CONSTRUCTION CONTRACT CHANGE ORDER NUMBER: 5

CCSJ:	0921-02-321
Project:	STP 2021(256) MM
Highway:	Mile 3 N
County:	Hidalgo
District:	21-Pharr
Contract Number:	C-20-294-02-23

Change Order #5
Mile 3 N Road

Project: Mile 3 N Road
Project #: STP 2021 (256) MM
Contract: C-20-294-02-23
CSJ: 0921-02-321
Limits: Tom Gill Road to FM 492 (Goodwin Road)

181a

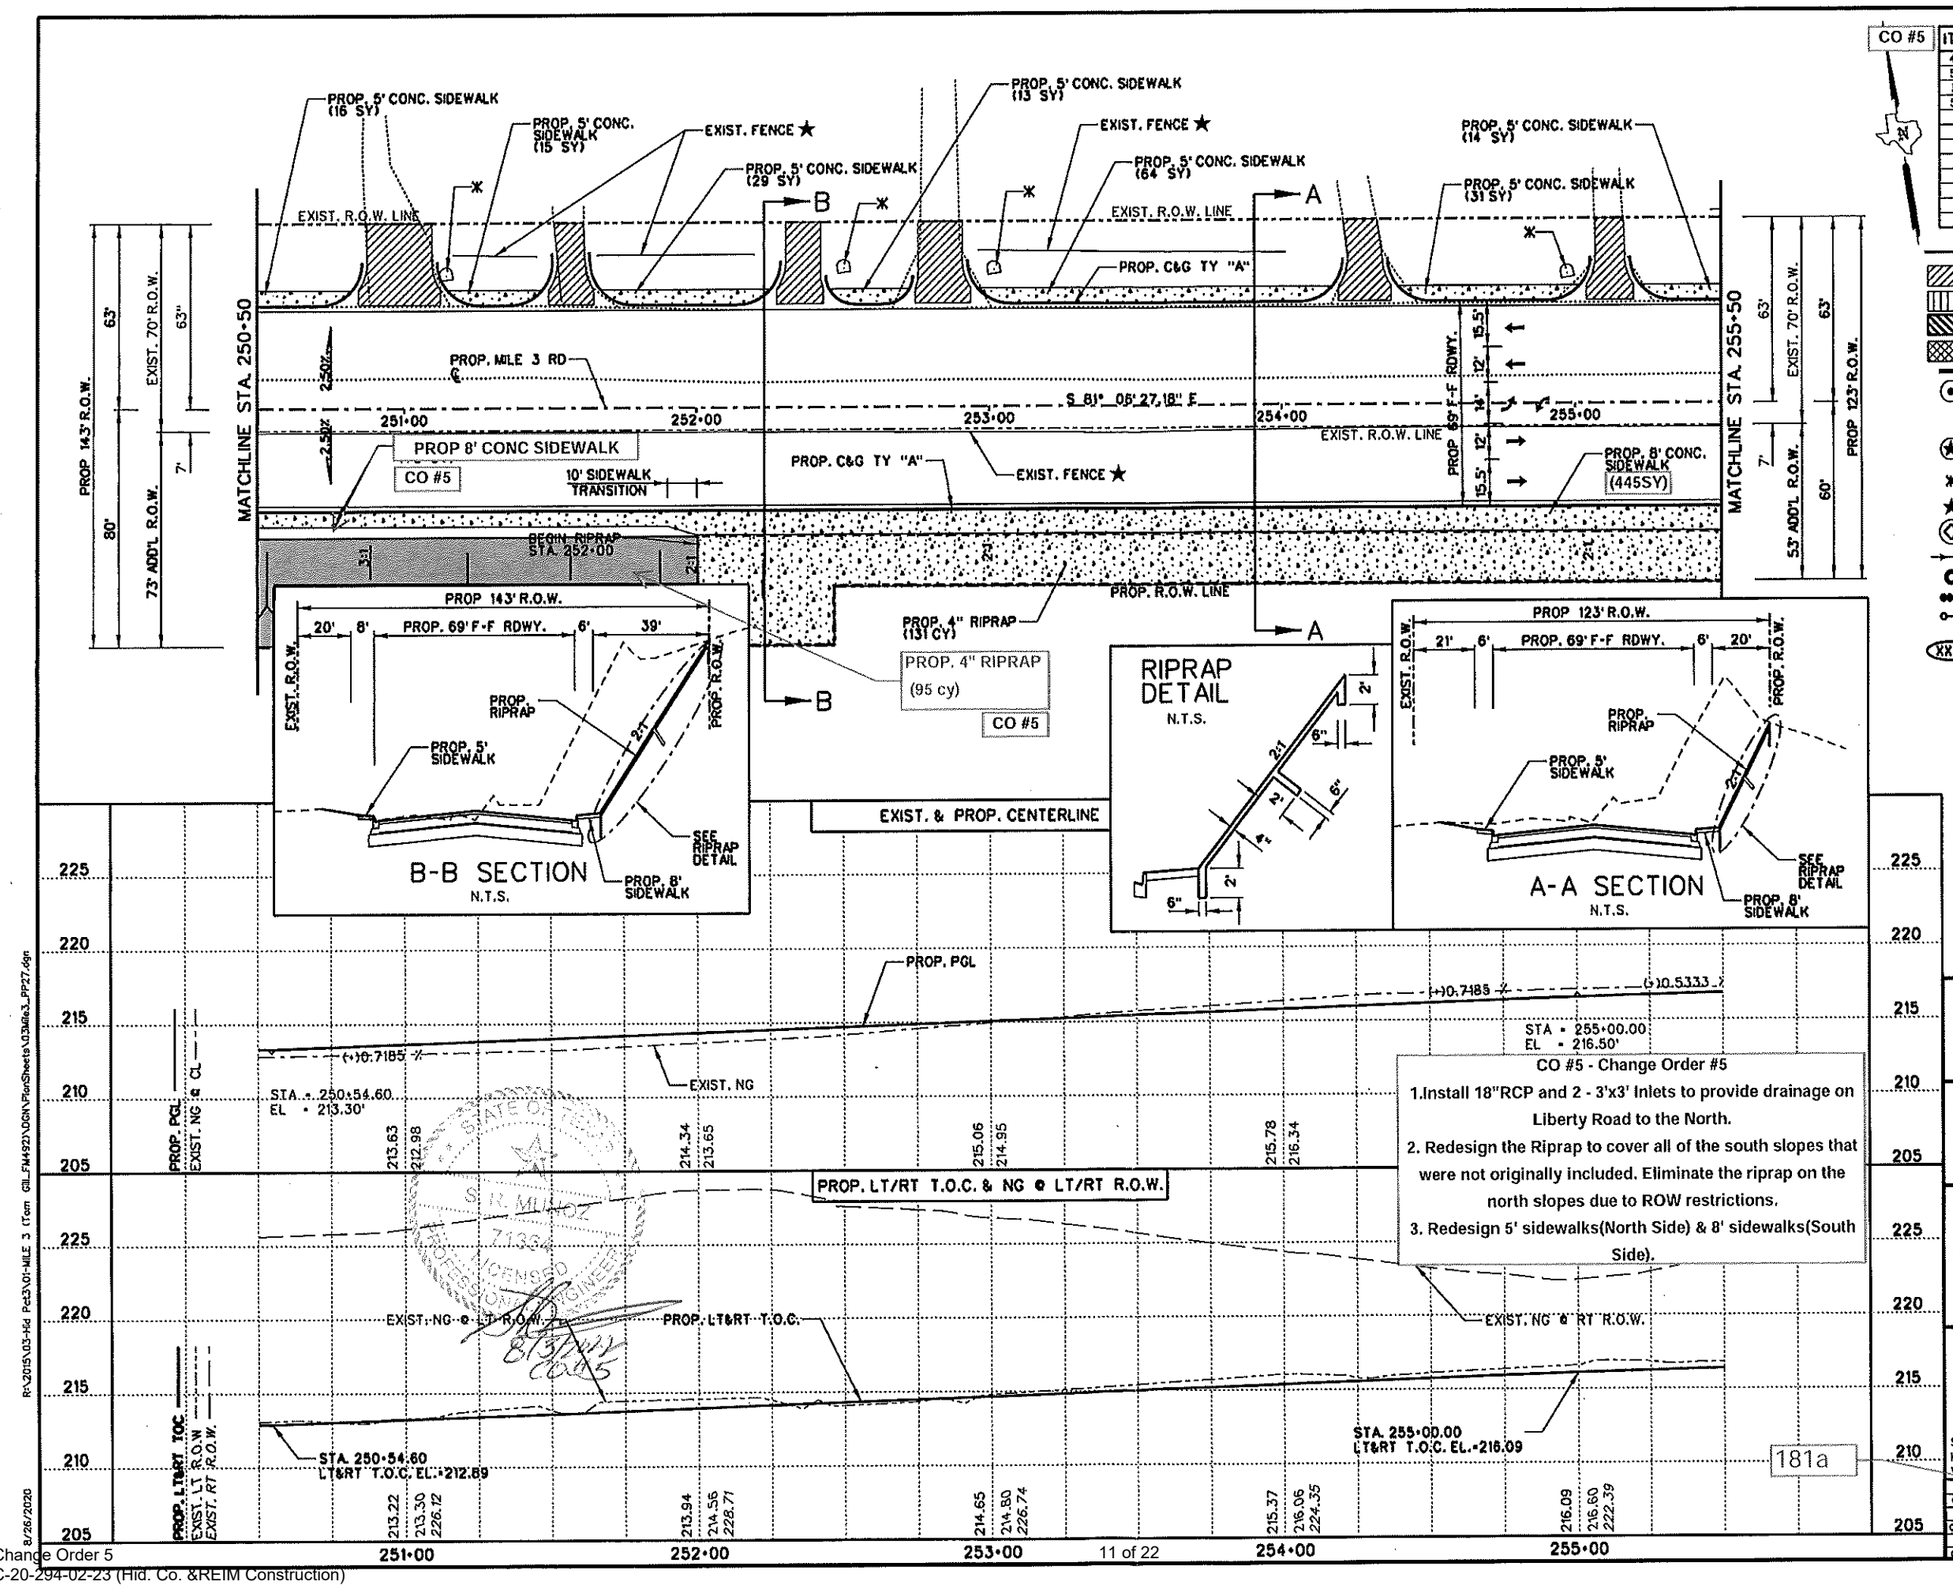
1. Install 18"RCP and 2 - 3'x3' Inlets to provide drainage on Liberty Road to the North.
2. Redesign the Riprap to cover all of the south slopes that were not originally included. Eliminate the riprap on the north slopes due to ROW restrictions.
3. Redesign 5' sidewalks(North Side) & 8' sidewalks(South Side).

CO #	ITEM	DESCRIPTION	UNIT	QUANTITY
	432	CONC. RIPRAP (4")	CY	226
	529	CONC. CURB & GUTTER (TY "A")	LF	1000
	531	CONC. SIDEWALK (4")	SY	627
	560	MAILBOX INSTALLATION (SINGLE)	EA	4

183a

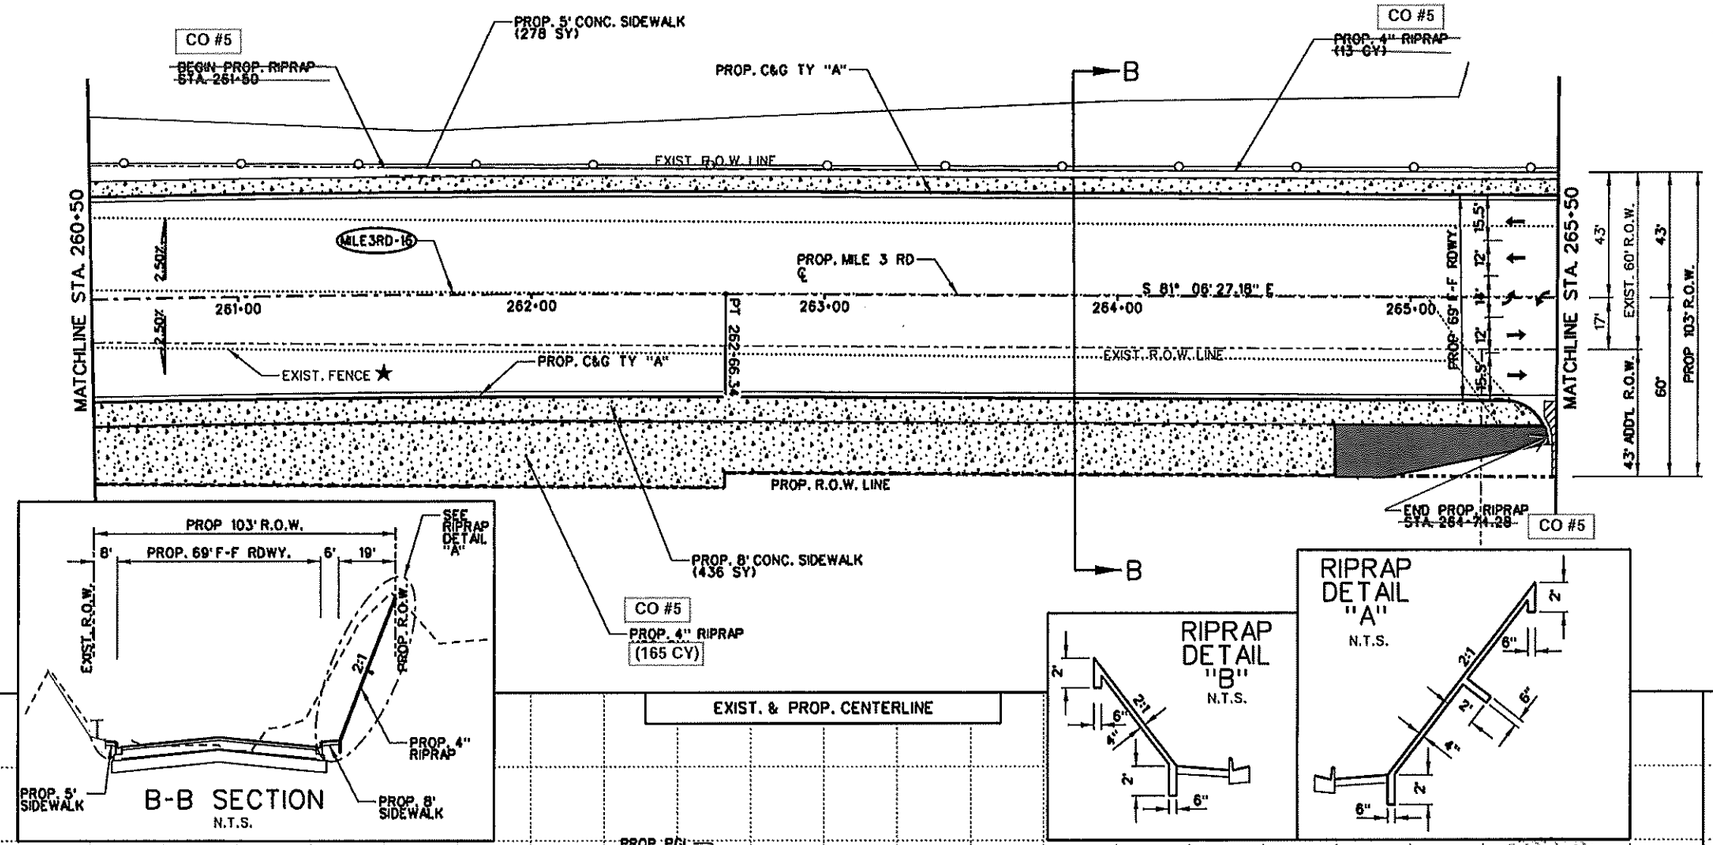
1. Install 18"RCP and 2 - 3'x3' Inlets to provide drainage on Liberty Road to the North.
2. Redesign the Riprap to cover all of the south slopes that were not originally included. Eliminate the riprap on the north slopes due to ROW restrictions.
3. Redesign 5' sidewalks(North Side) & 8' sidewalks(South Side).

ITEM	DESCRIPTION	UNIT	QUANTITY
432	CONC. RIPRAP (4")	CY	165
529	CONC. CURB & GUTTER (TY "A")	LF	1000
531	CONC. SIDEWALK (4")	SY	714

DH	FED.RD. DIV.NO.	STATE	PROJECT NO.				HIGHWAY NO.
CK DW D.B.T.	6	TX	STP	(	)MM		MILE 3
DW D.B.T.	STATE DIST.NO.	COUNTY	CONTROL NO.	SECTION NO.	JOB NO.		SHEET NO.
CK D.B.T.	21	HIDALGO	0921	02	321		266
TR							
CK TRI

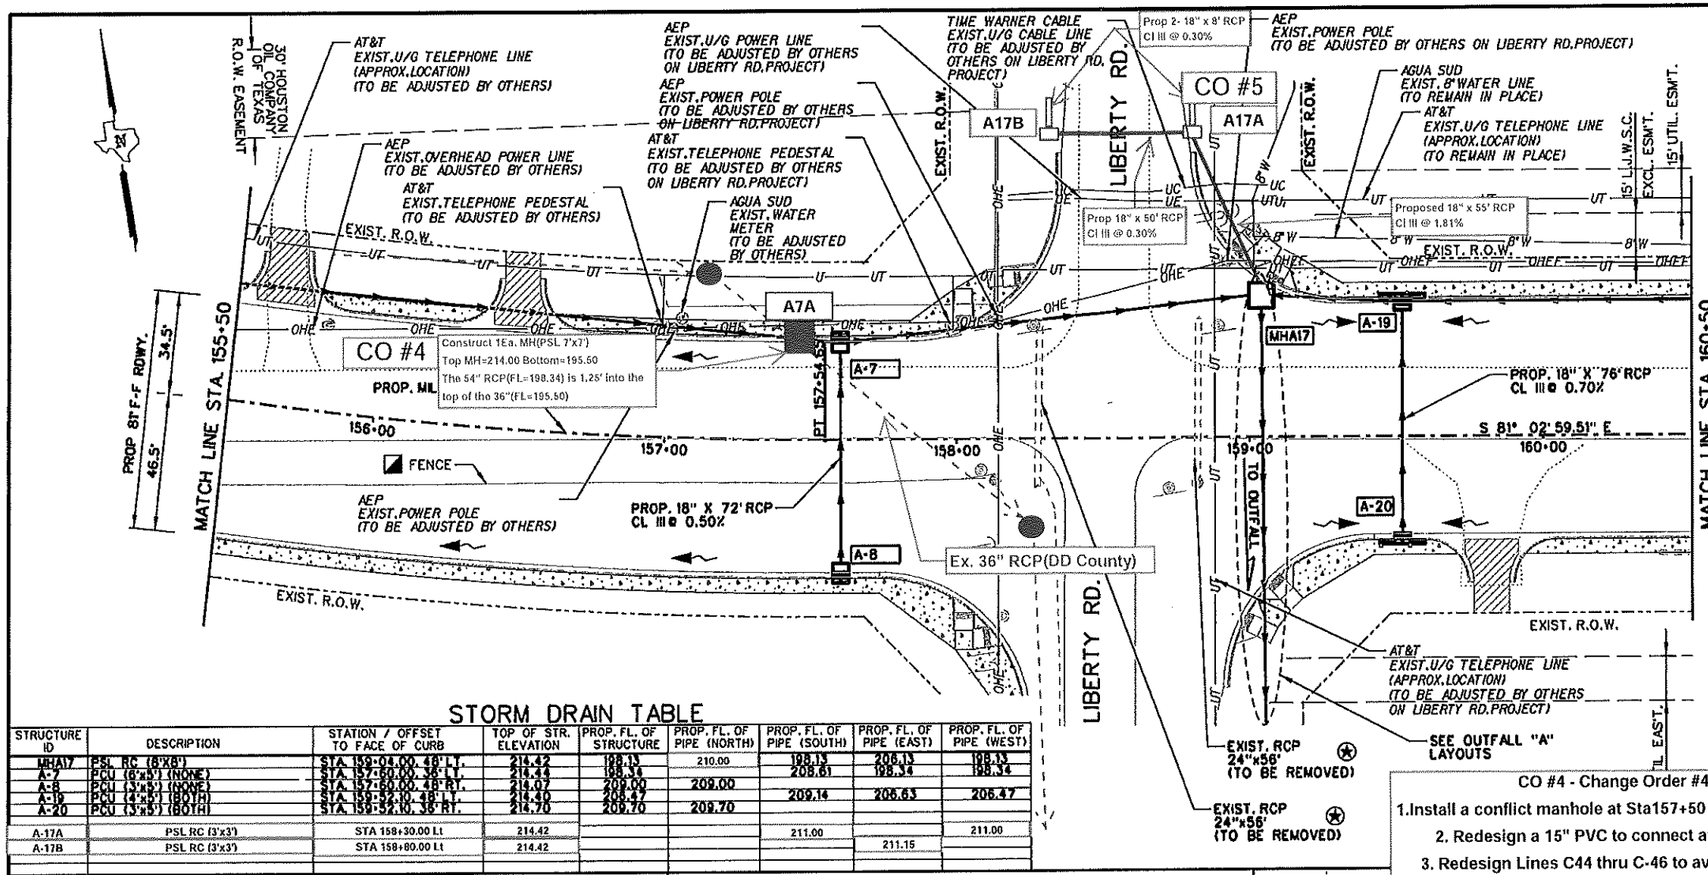
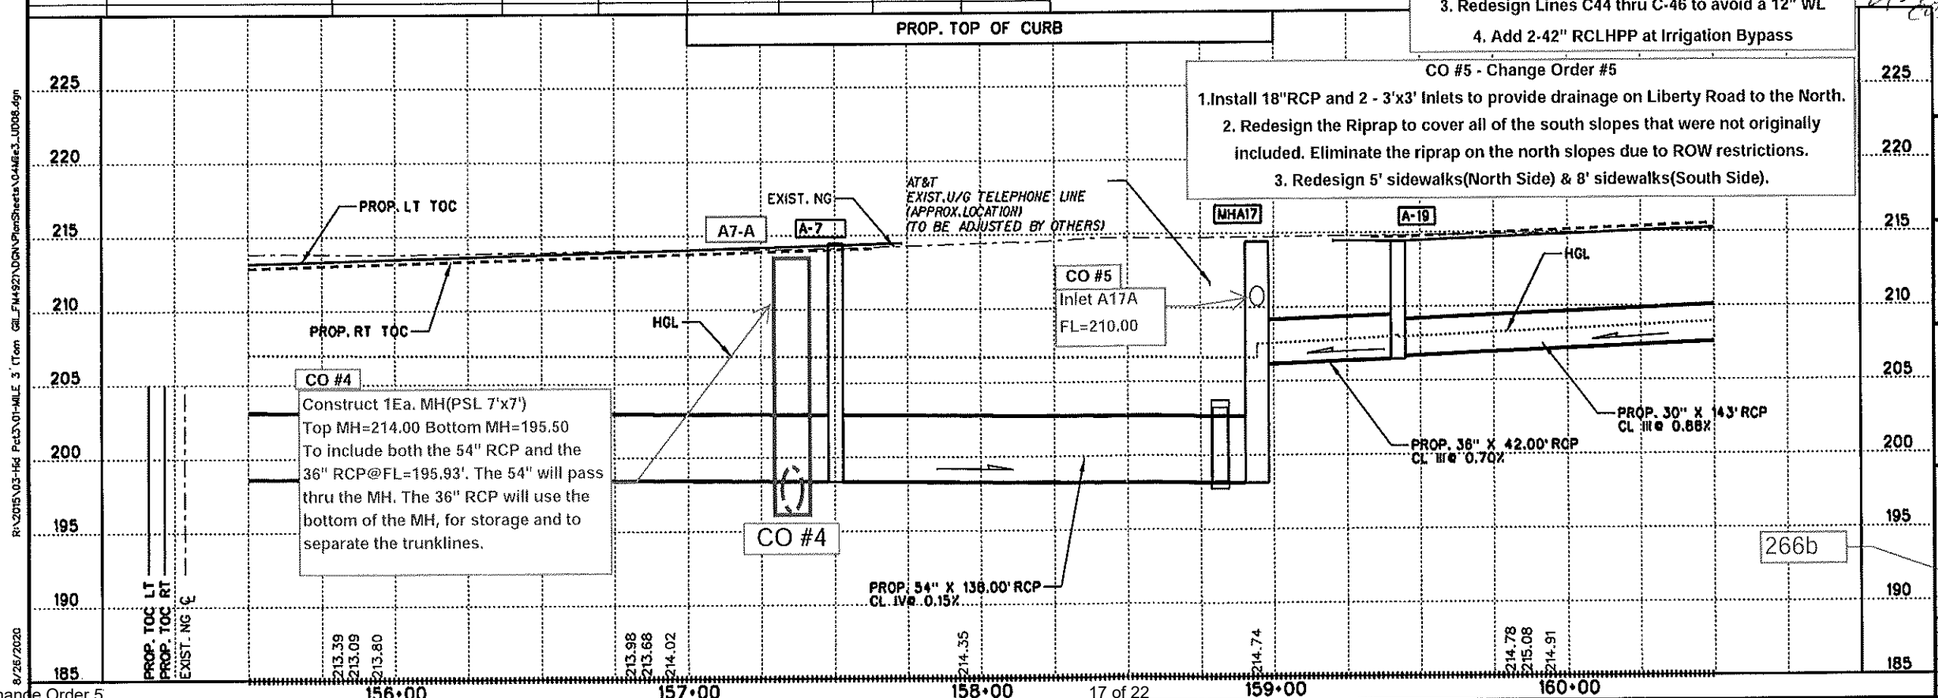
1. Install 18"RCP and 2 - 3'x3' Inlets to provide drainage on Liberty Road to the North.
2. Redesign the Riprap to cover all of the south slopes that were not originally included. Eliminate the riprap on the north slopes due to ROW restrictions.
3. Redesign 5' sidewalks(North Side) & 8' sidewalks(South Side).

STRUCTURE ID	DESCRIPTION	STATION / OFFSET TO FACE OF CURB	TOP OF STR. ELEVATION	PROP. FL. OF STRUCTURE	PROP. FL. OF PIPE (NORTH)	PROP. FL. OF PIPE (SOUTH)	PROP. FL. OF PIPE (EAST)	PROP. FL. OF PIPE (WEST)
MHA17	PSL RC (8'X8')	STA 159+06.00, 48' LT.	214.42	198.13	210.00	198.13	208.13	198.13
A-7	PCU (6'x5') (NONE)	STA 157+60.00, 36' LT.	214.44	198.34	209.00	208.61	198.34	198.34
A-8	PCU (3'x5') (NONE)	STA 157+60.00, 48' RT.	214.07	209.00				
A-19	PCU (4'x5') (BOTH)	STA 159+52.30, 48' LT.	214.40	206.47	209.14	206.63	206.47	
A-20	PCU (3'x5') (BOTH)	STA 159+52.30, 36' RT.	214.70	206.70	209.70			
A-17A	PSL RC (3'x3')	STA 158+30.00 Lt	214.42		211.00		211.00	
A-17B	PSL RC (3'x3')	STA 158+80.00 Lt	214.42			211.15

ITEM	DESCRIPTION	UNIT	QUANTITY
496	REMOVE (PIPE)	LF	112
464	RC PIPE (CL. III) (18 IN) (SPL)	LF	121

170a

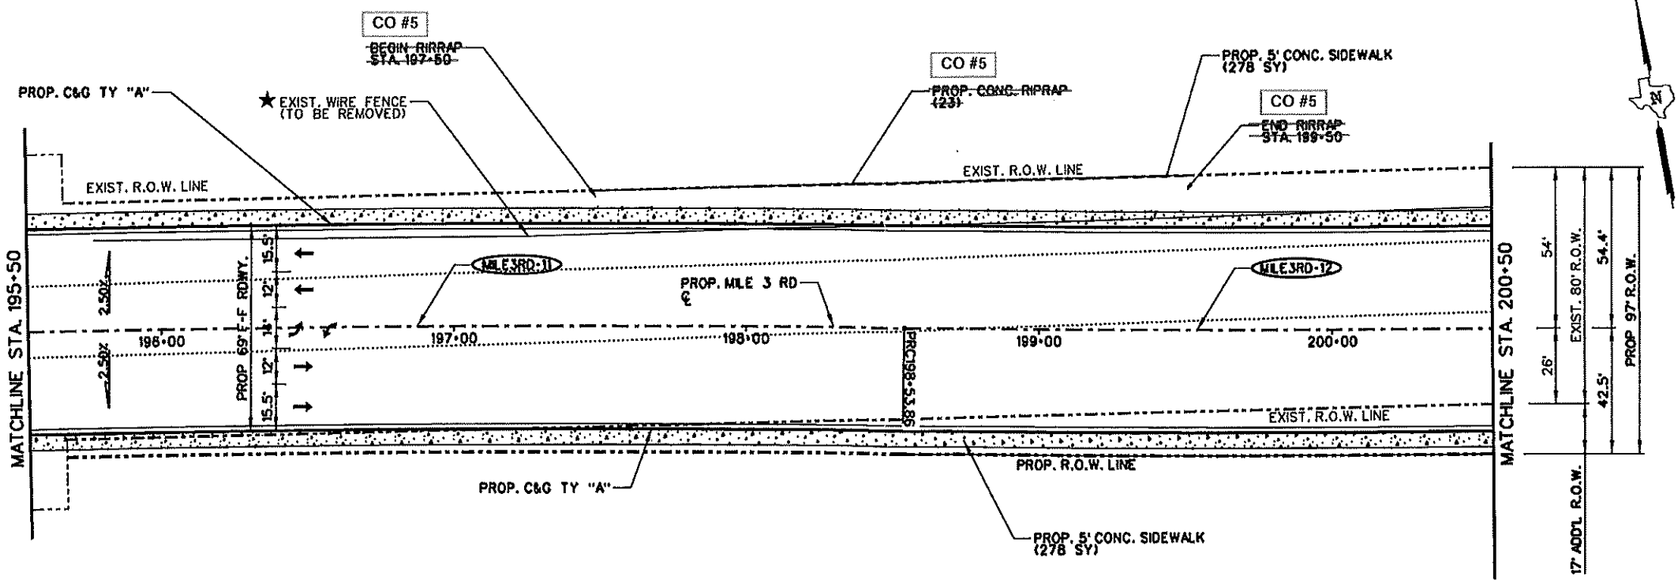
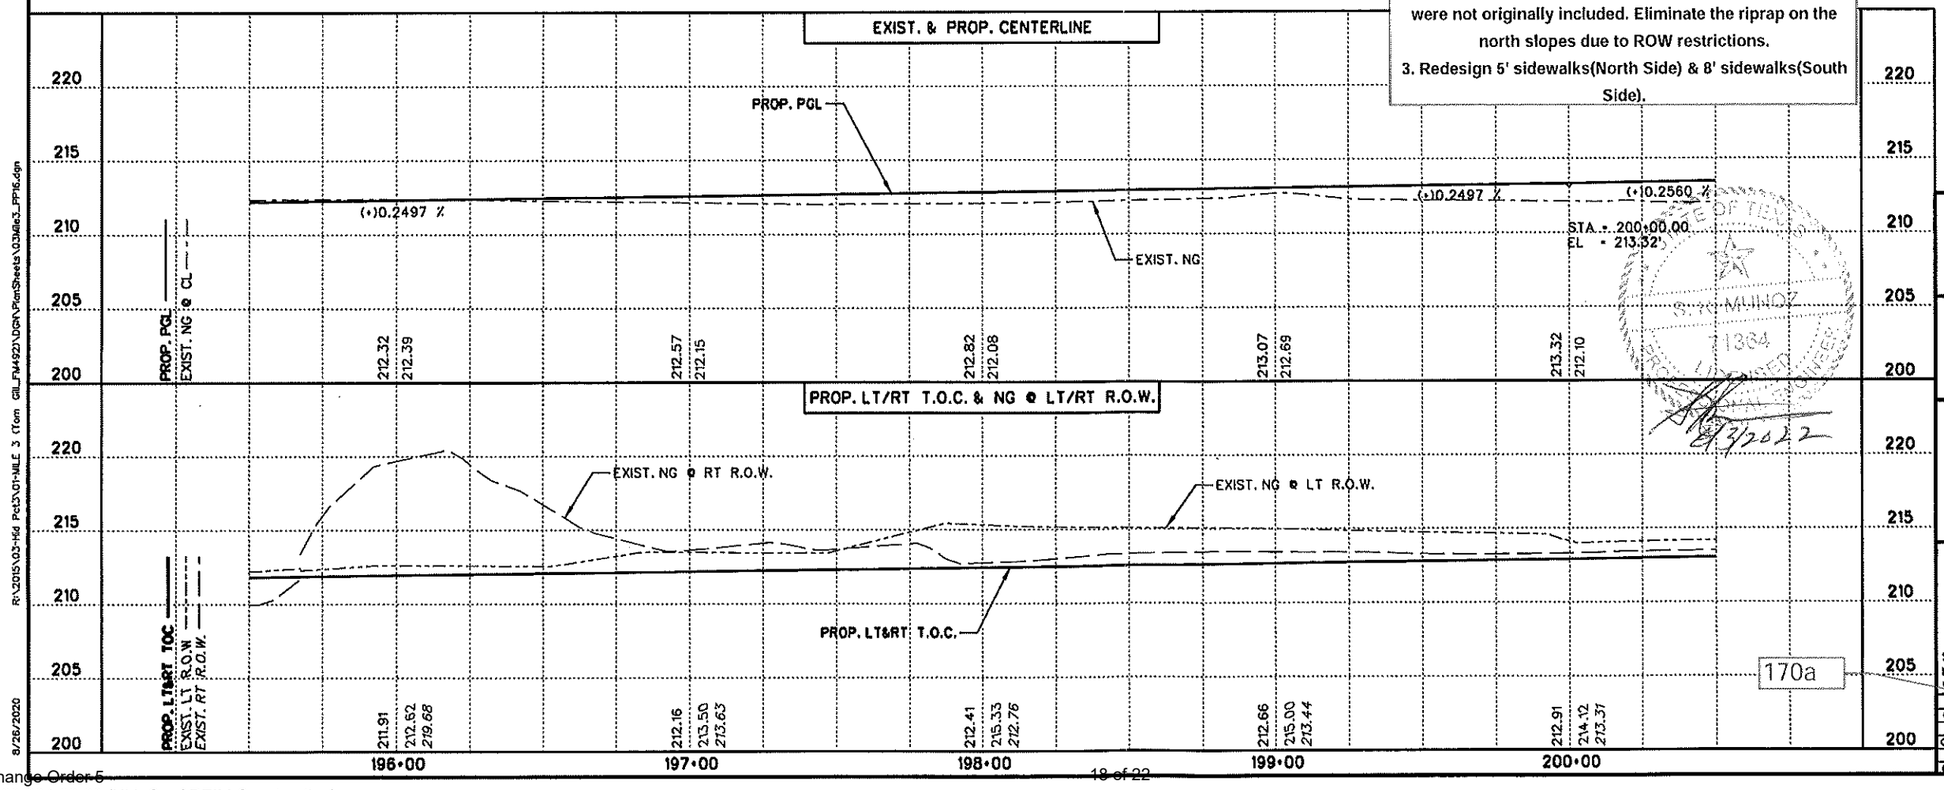
1. Install 18"RCP and 2 - 3'x3' Inlets to provide drainage on Liberty Road to the North.
2. Redesign the Riprap to cover all of the south slopes that were not originally included. Eliminate the riprap on the north slopes due to ROW restrictions.
3. Redesign 5' sidewalks(North Side) & 8' sidewalks(South Side).

SHEET SUMMARY			
ITEM	DESCRIPTION	UNIT	QUANTITY
432	CONC. RIPRAP (4")	CY	0
529	CONC. CURB & GUTTER (TY "A")	LF	1000
531	CONC. SIDEWALK (4")	SY	556
